RE: Development Application D/2017/1609/A at 93-97 Macquarie Street, Sydney

**Submission on Proposed Developments Sir Stamford Hotel (D/2017/1609/A and D/2024/324) –
93-97 Macquarie Street, Sydney NSW**

**re: D/2017/1609/A: Section 4.55(2) Modification Application (“the Modification Application”)
93-97 Macquarie Street (“the site”)
Modification of the concept approval to amend the building envelope to be consistent with the detailed design development application D/2024/324 (“the proposed modification”)**

Figure 1 – Relationship between development site and Transport House

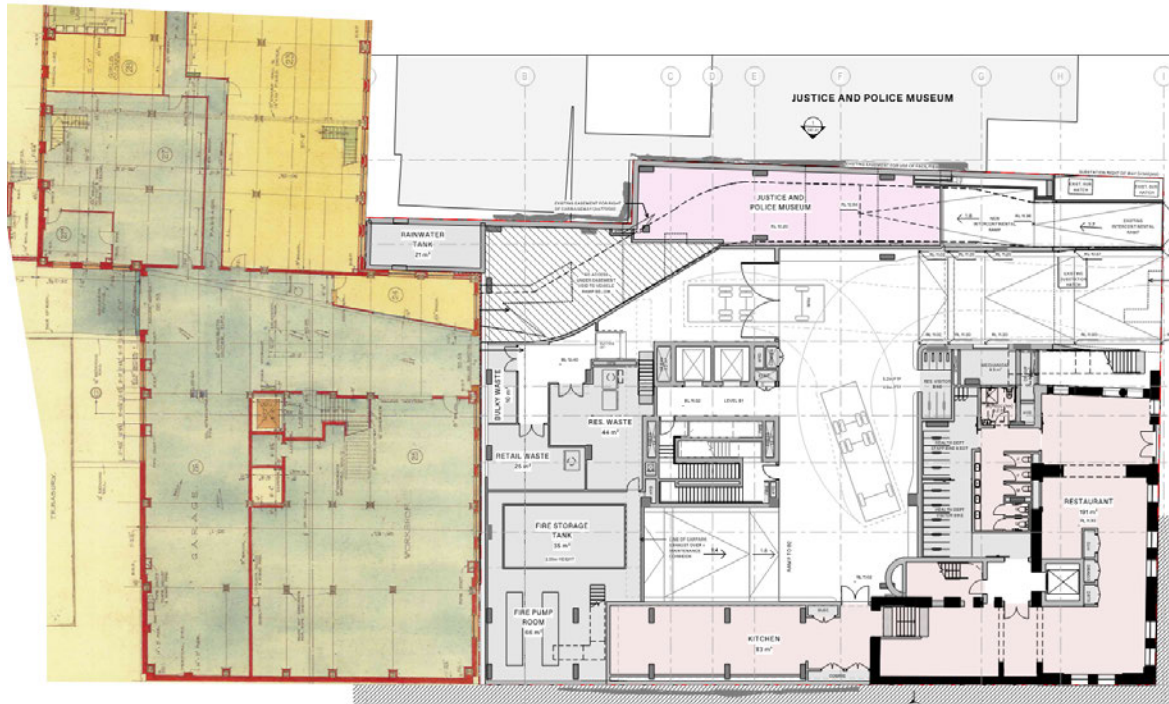
Structural impacts on Transport House relate primarily to the proximity of the development to the existing structure. The layout of the site in relation to Transport House can be seen in Figure 1. This shows the new basement structures in close proximity to the northeast corner of Transport House.

Key structural impacts on Transport House from the proposed developed as outlined in DA D/2017/1609/A include:

Figure 2 Existing vehicle access arrangements – Intercontinental Hotel

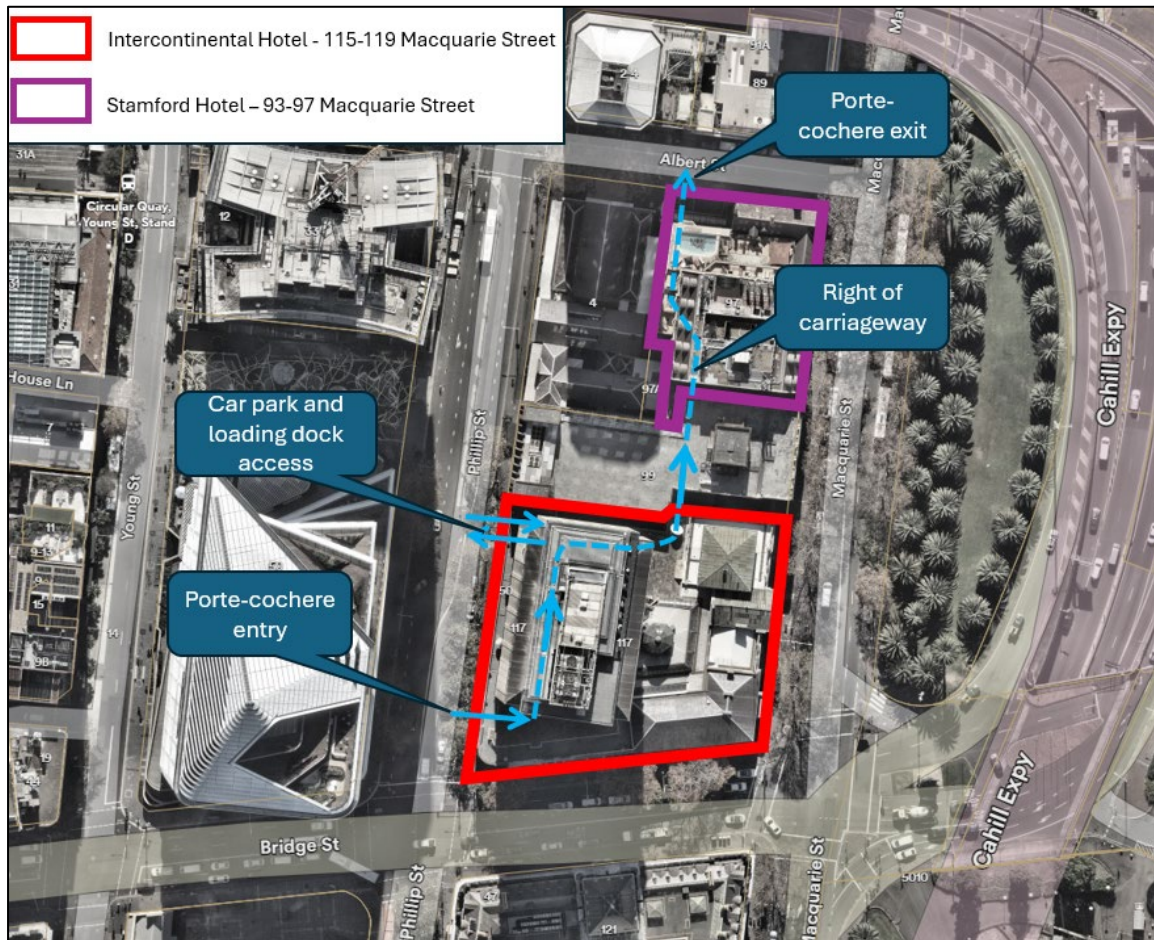
The Intercontinental Hotel has a vehicle entry off Phillip Street which provides access to both the car park and the loading area. In addition there is a one way roadway to access the Porte Cochere from the southern end of Phillip Street which exits via a right of carriageway to Albert Street which supports egress from the Porte Cochere. These existing vehicle access arrangements are presented in Figure 2 below.

Figure 4 Existing right of carriageway through the 93-97 Macquarie Street

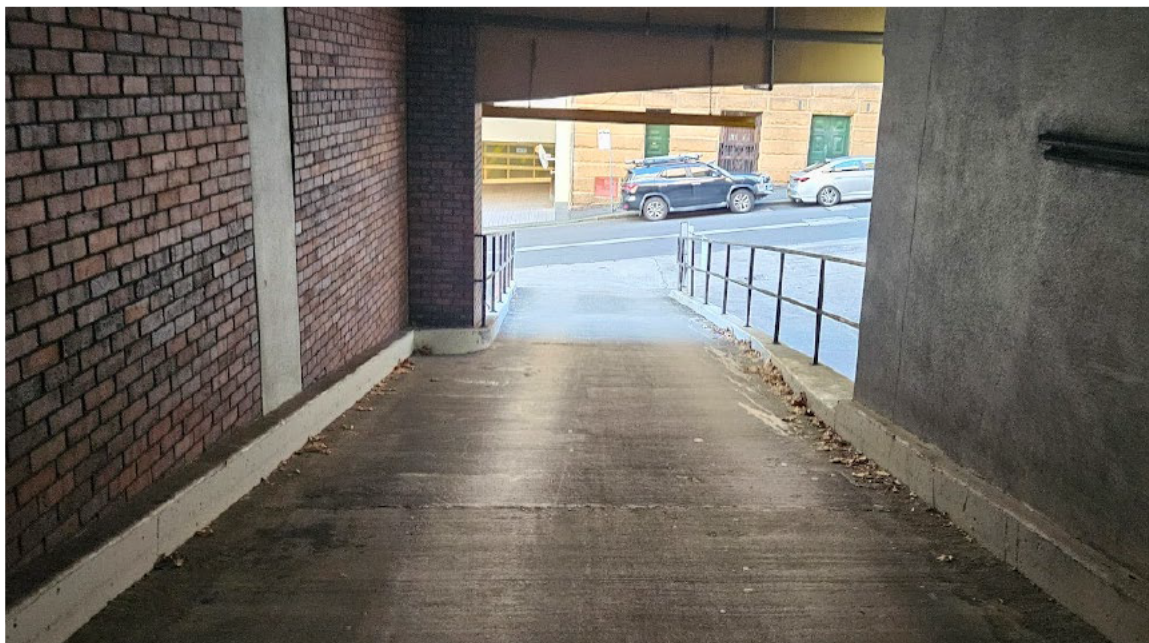
A photograph of the existing right of carriageway through the 93-97 Macquarie Street and connecting with Albert Street is shown in Figure 4.
